VCPS - New School

210 12th Street NE, Valley City, ND 58072
Project #: 24-028
Addendum 02
03/24/2026

Sheet C601 – Grading Plan - Field

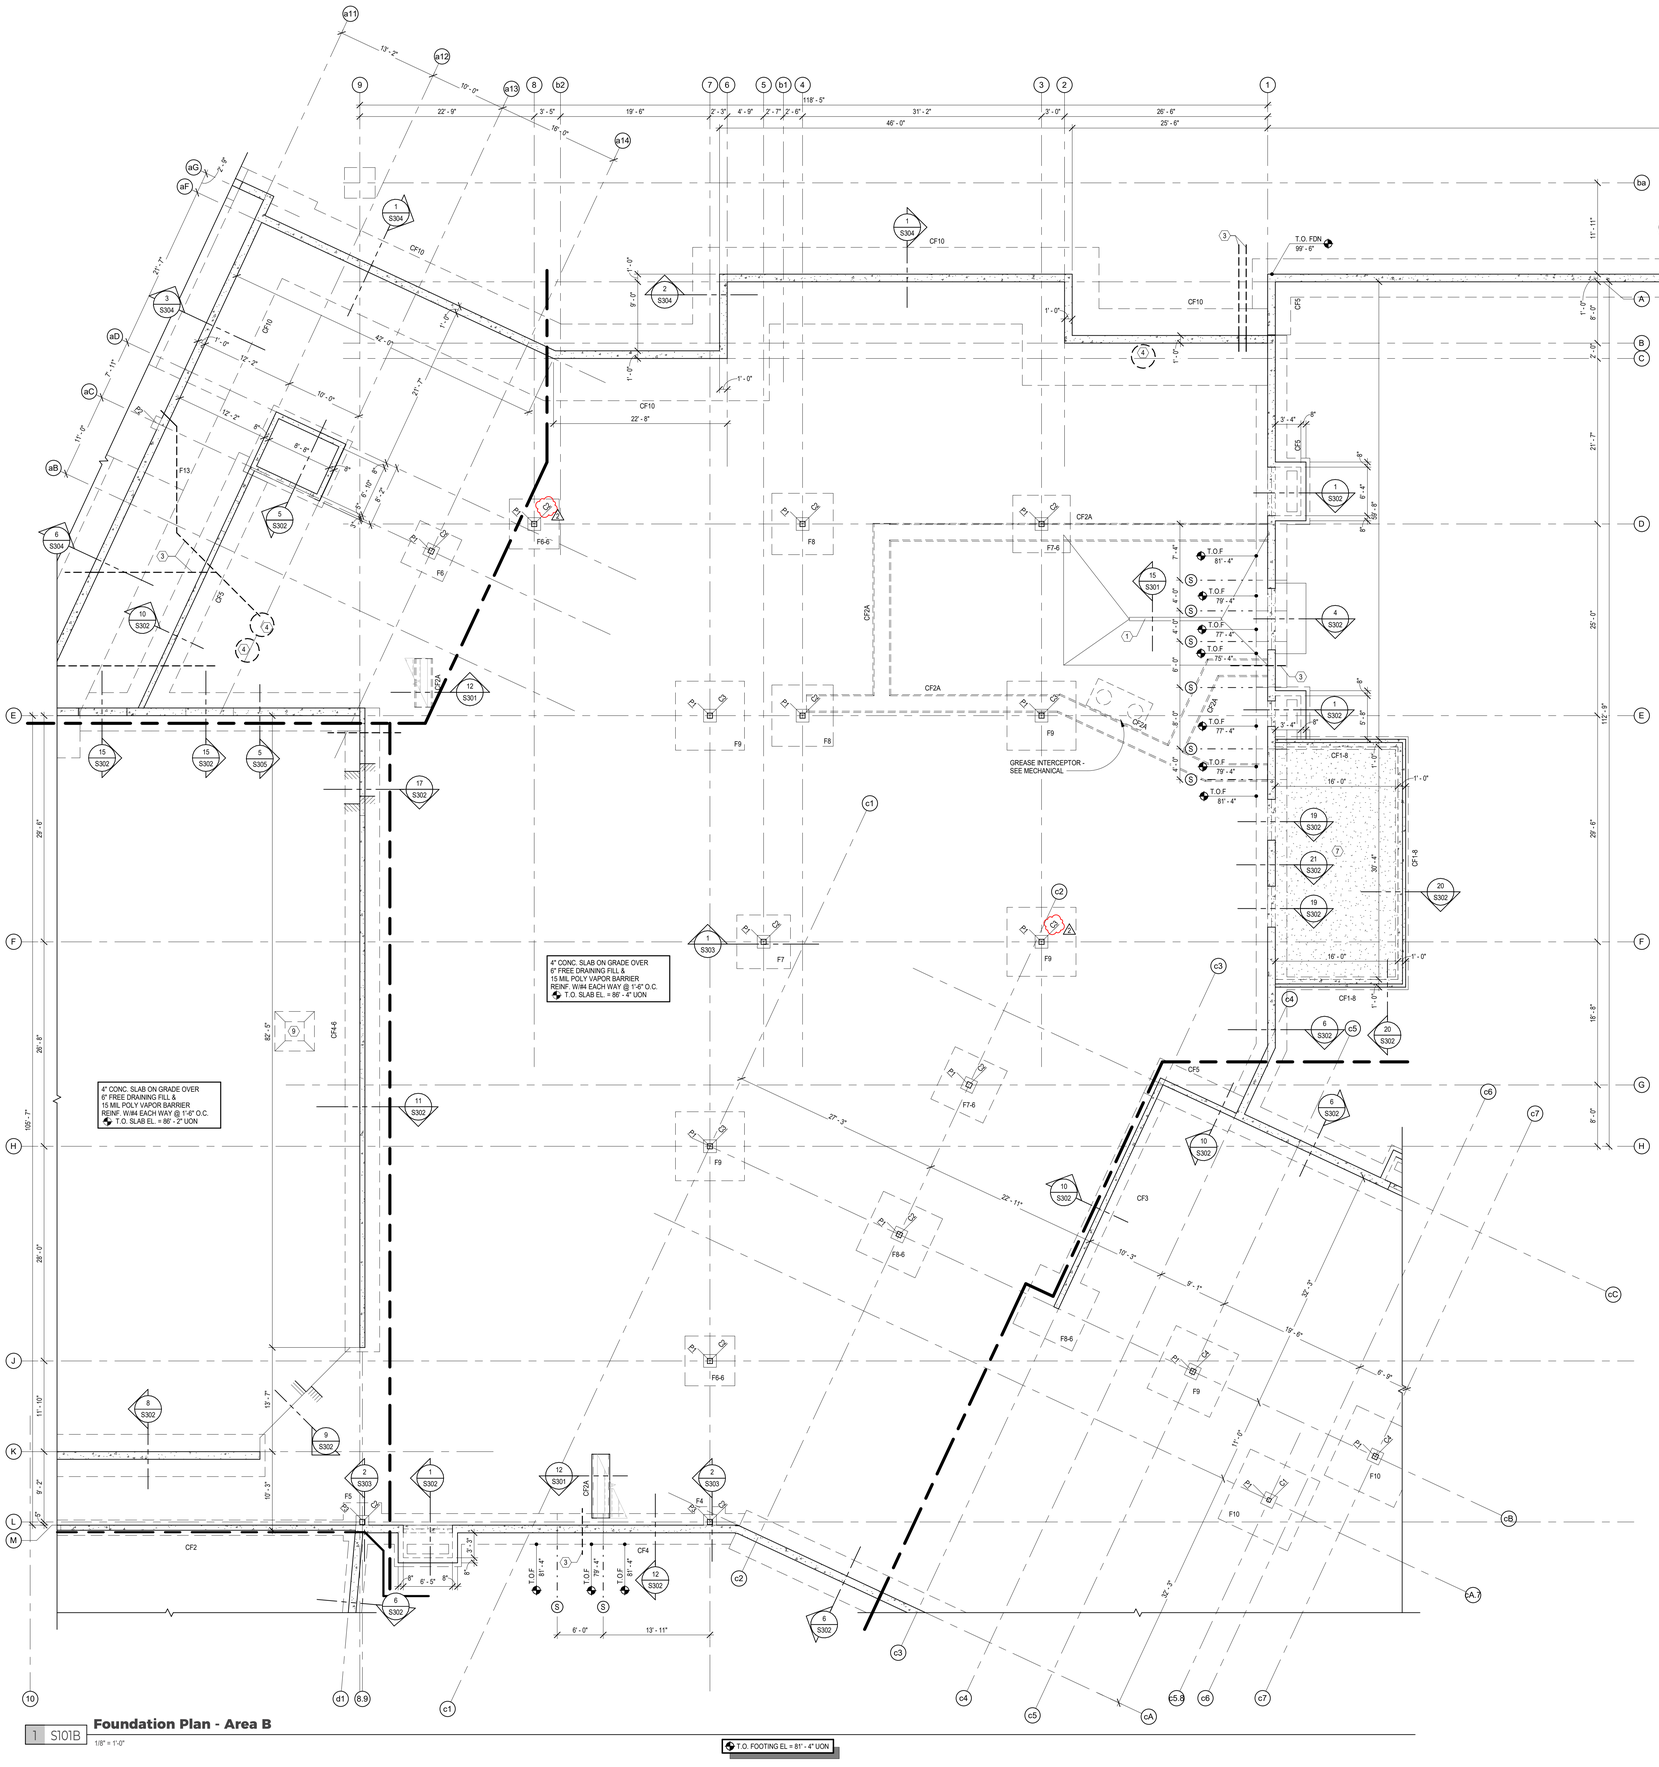
1. Removed irrelevant notes and added fabric note.

S101D – FOUNDATION PLAN – AREA D

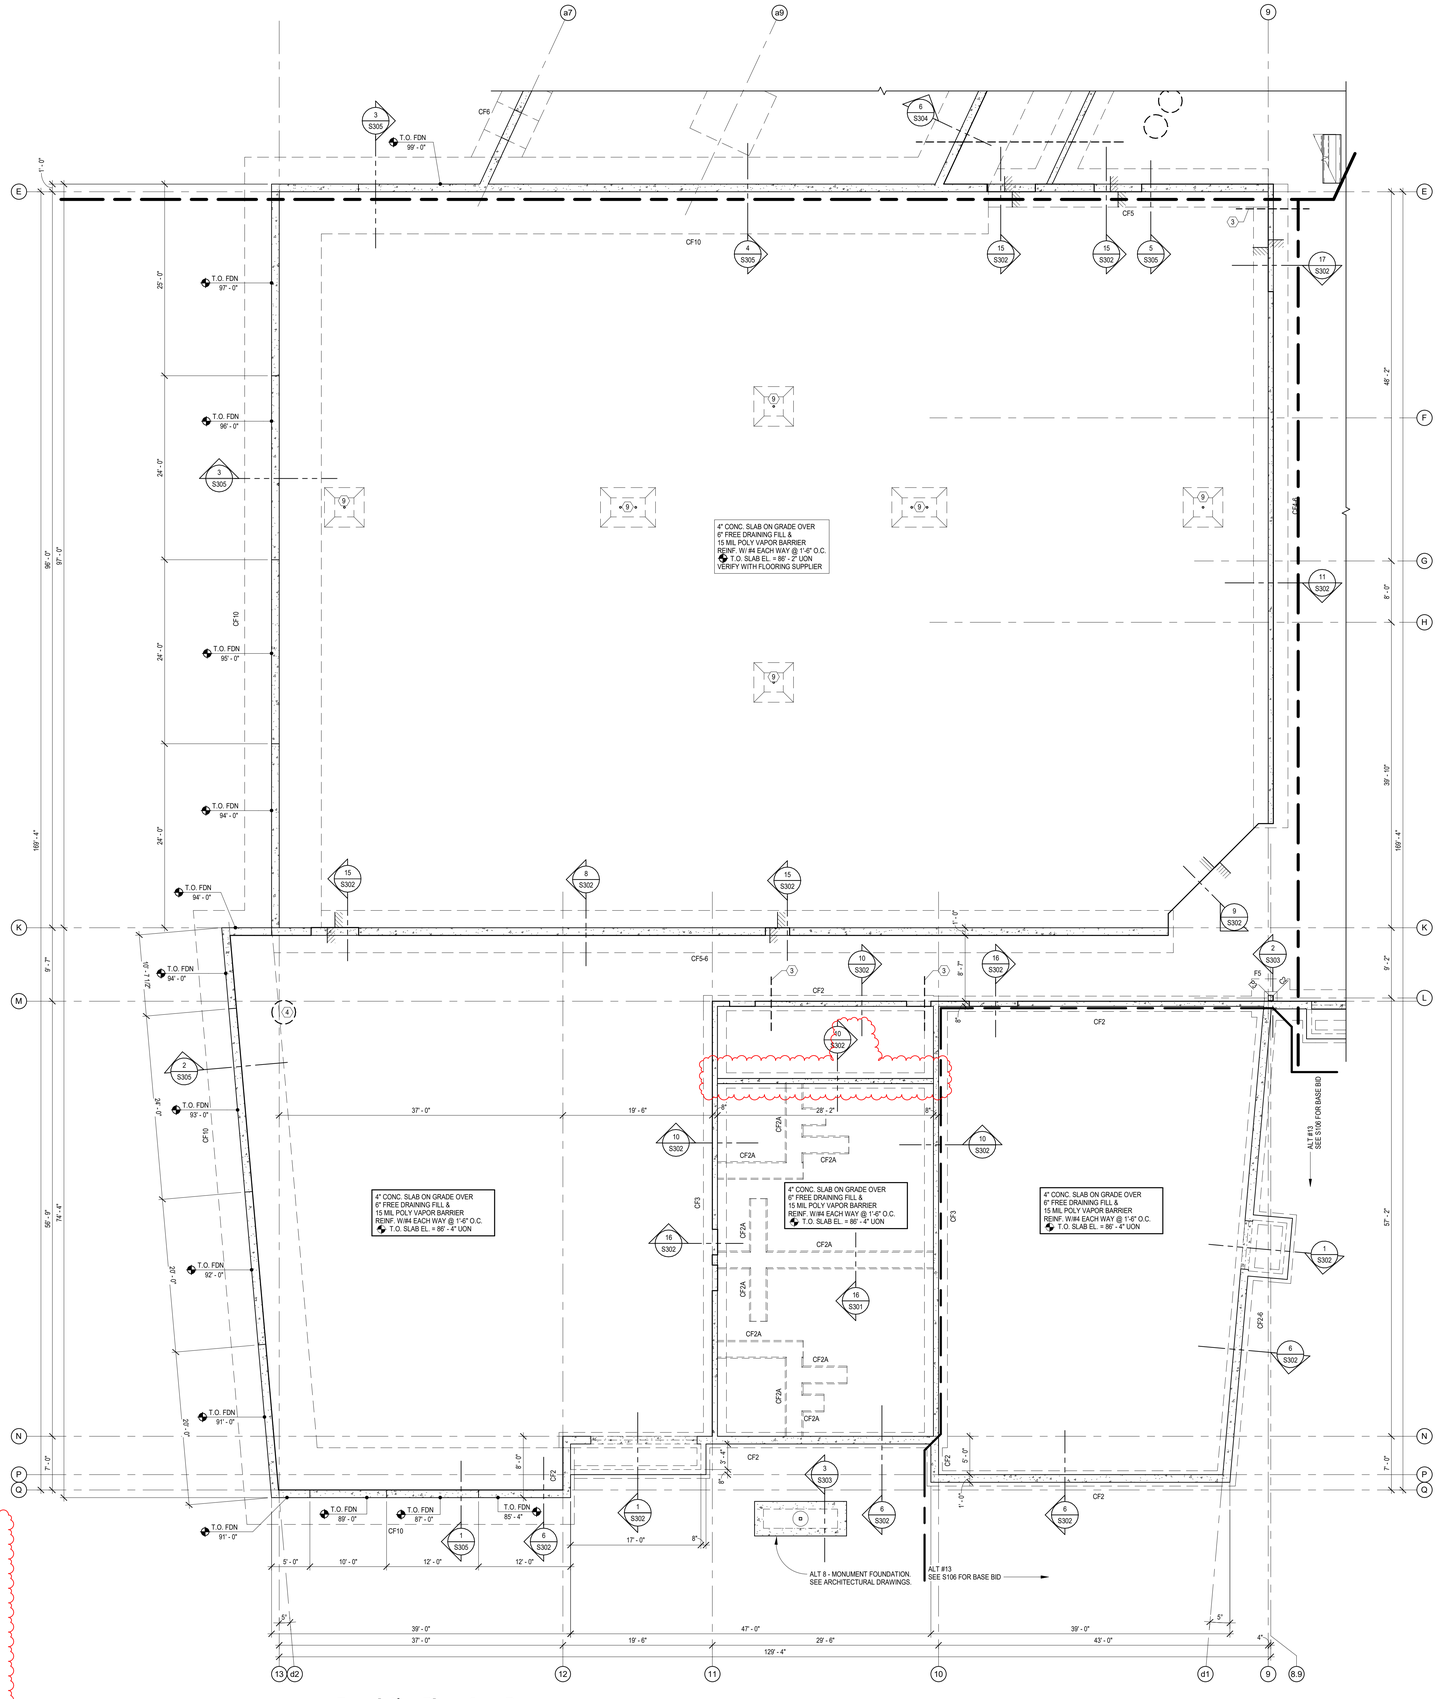
1. Update Wall / Strip Footing Schedule as shown
2. Add view 2/S101D for precast monument sign foundation
3. Update foundation to be cast in place for precast wall between Grids 10 & 11

S102C – FRAMING PLAN – LEVEL 01 – AREA C

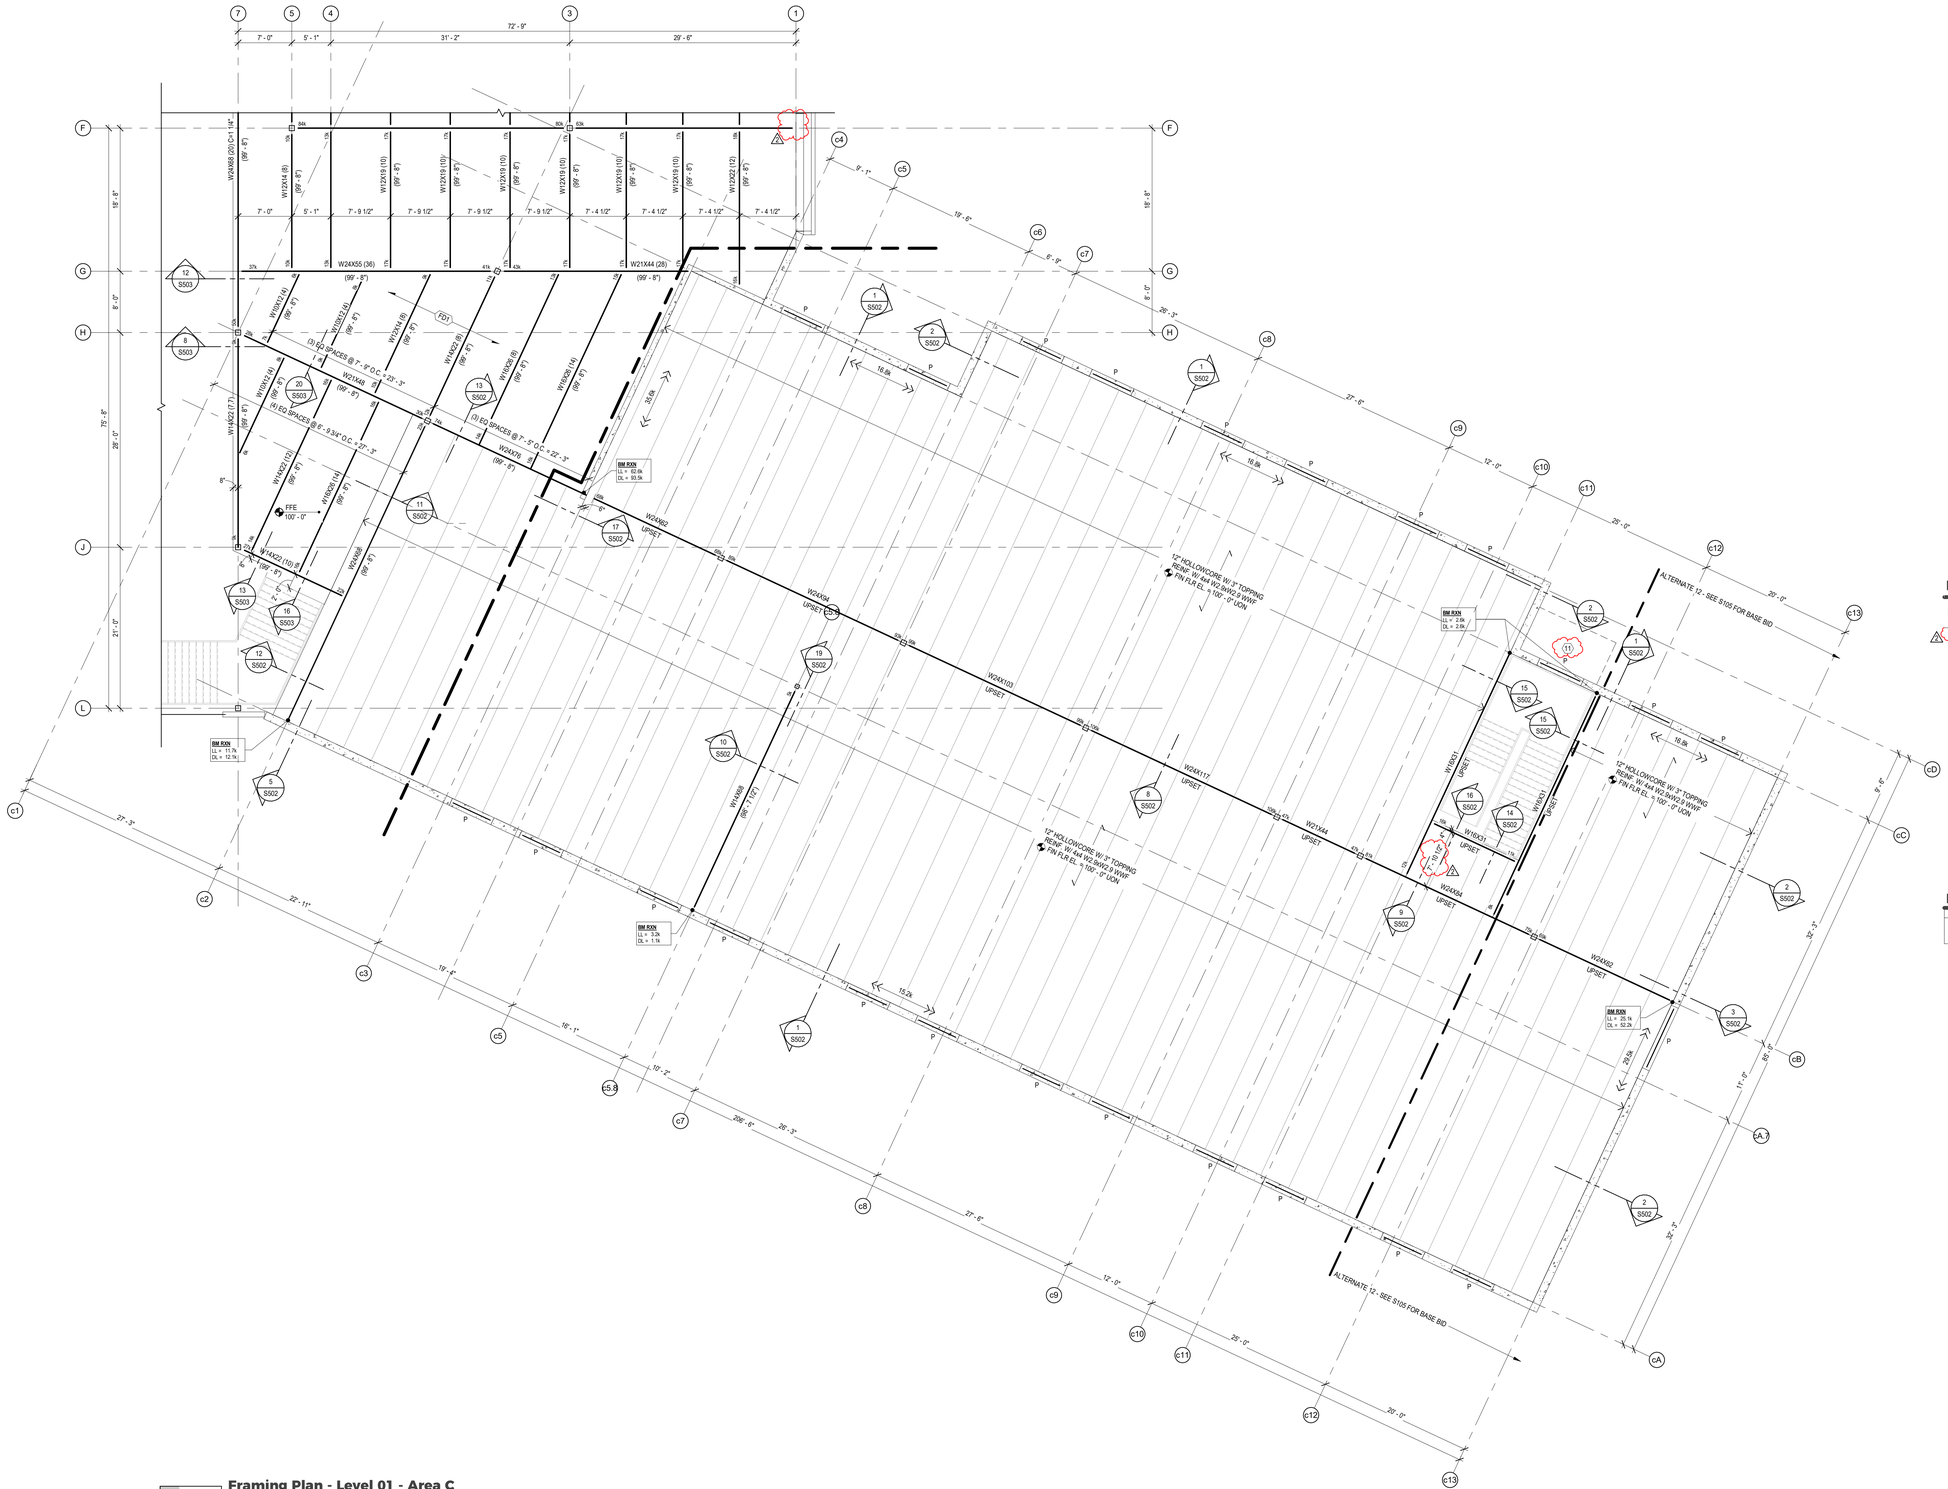
1. Add Keynote 11 on plan & to schedule for canopy.

S102D – ROOF FRAMING PLAN – LOW ROOF – AREA D

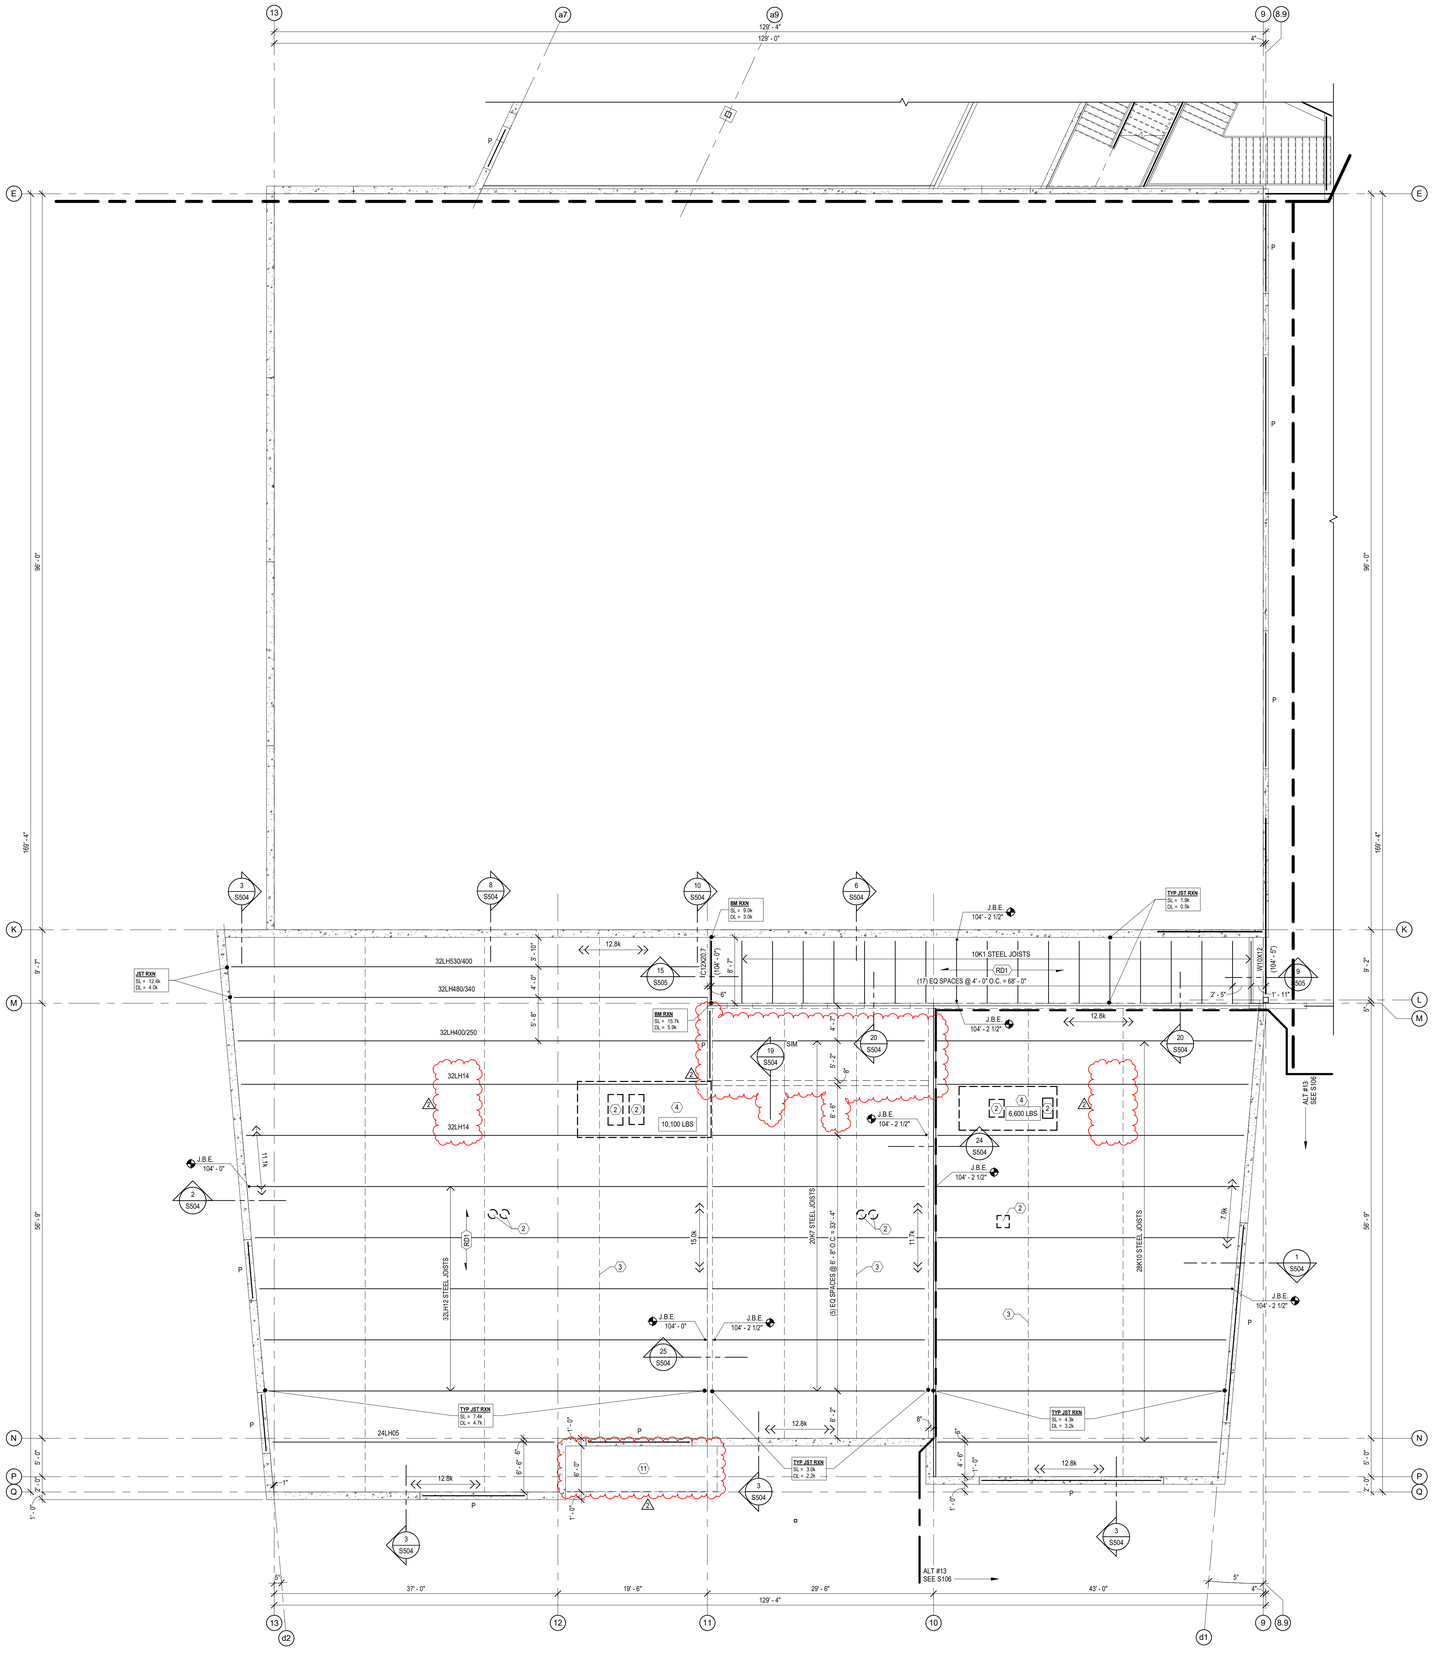
1. Add Keynote 11 on plan & to schedule for canopy.
2. Add precast wall / remove joist & add detail callout 19/S504 between Grids 10 & 11
3. Update joist designations supporting mechanical units.
